SUNDRY NOTICES AND REPORTS ON WELLS

2 Name of Operator
Murchison Oil and Gas

8 Well Name and No
Mudcat Federal Com #2H

9 API Well No
30-015-40617

HWD Rig 4 Choke Manifold

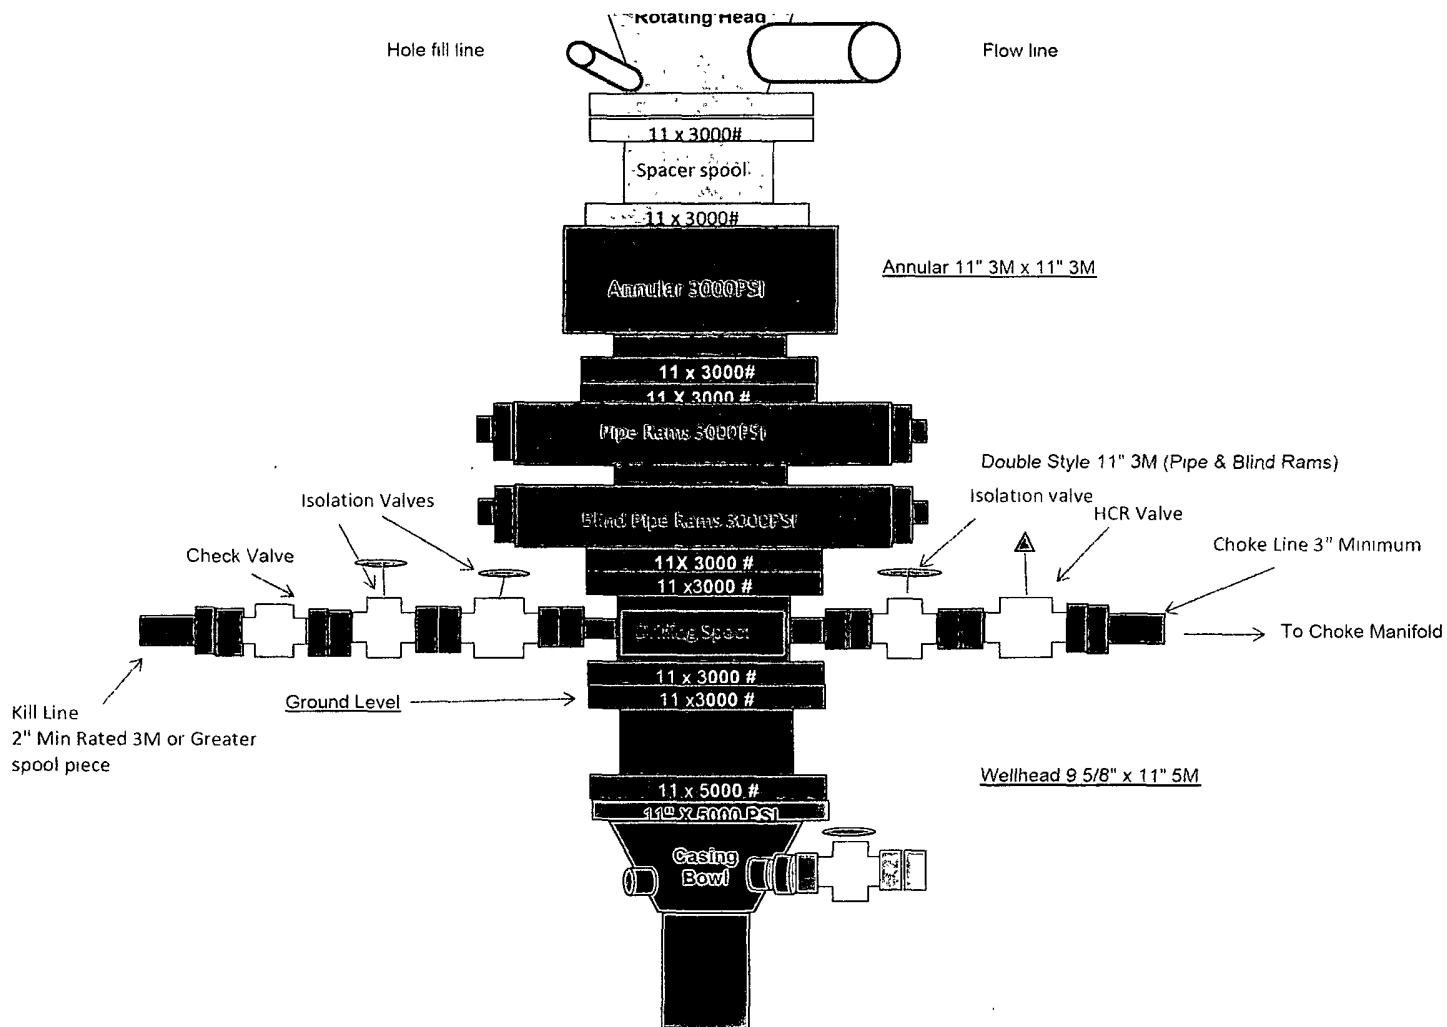
As well we request to change the choke manifold, BOP stack, and rig layout. See attached schematics.

2. BOP and choke manifold approved as presented.
3. Rig layout approved as long as no additional surface disturbance occurred due to the change.
4. Variance approved to use flex line from BOP to choke manifold. Check condition of flexible line from BOP to choke manifold, replace if exterior is damaged or if line fails test. Line to be as straight as possible with no hard bends and is to be anchored according to Manufacturer's requirements (i.e. operator shall install Midwest Hose & Specialty, Inc. approved hose safety clamp on the mid-section of the hose and connect to the sub-floor). The flexible hose can be exchanged with a hose of equal size and equal or greater pressure rating. **Anchor requirements, specification sheet and hydrostatic pressure test certification matching the hose in service, to be onsite for review.** If the BLM inspector questions the straightness of the hose, a BLM engineer will be contacted and will review in the field or via picture supplied by inspector to determine if changes are required (operator shall expect delays if this occurs).

Internal Hydrostatic Test Graph

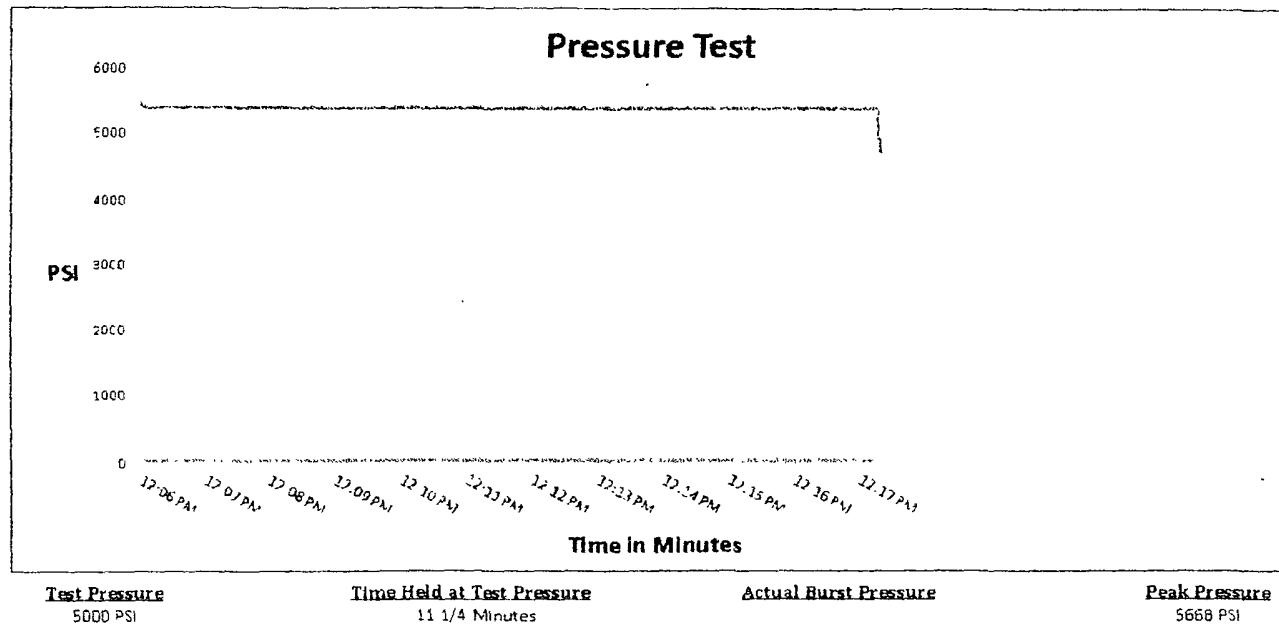
We request to use a coflex hose to go from the BOP stack to the Choke Manifold. See attached Hydrotest, and anchor requirements.
